CITY OF PLANTATION DEVELOPMENT REVIEW APPLICATION

Project Name:
8601 W. Sunrise Boulevard Conditional Use

Planning, Zoning and
Economic Development**PP20-0016: 8601 W. Sunrise Redevelopment****MEETING DATE:** October 5, 2021**PROJECT SUMMARY**A. Project Name / Number: 8601 W. Sunrise Redevelopment / PP20-0016B. Requests:

STAFF COMMENTS:**PLANNING & ZONING:****General comments:**

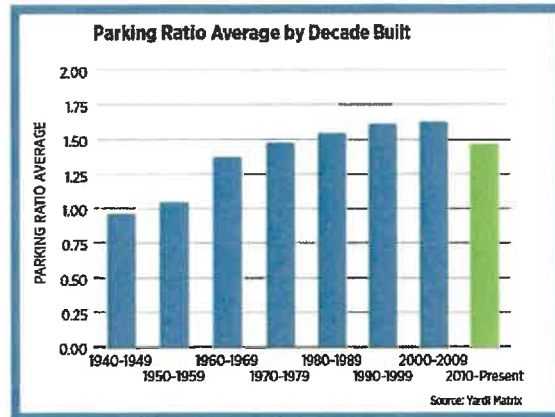
1. **From:** Section 27-689 which states that minimum setbacks need to be 1.5 times the height of the building.

To: Our dimensions vary throughout the project as detailed on page A2.1 of the submittal package. The setback from the parking garage to the north property line has been increased from 21'0" to 41'2" with this submittal.

Justification: The Code required setbacks would have a substantial impact on the amount of buildable space and park area the Applicant would be able to provide. With this waiver, a larger green area and a larger amenity area can be provided. Additionally, parking ratios, pedestrian walking paths, amenity areas, and circulation would also be negatively impacted if the Applicant was required to meet the Code.
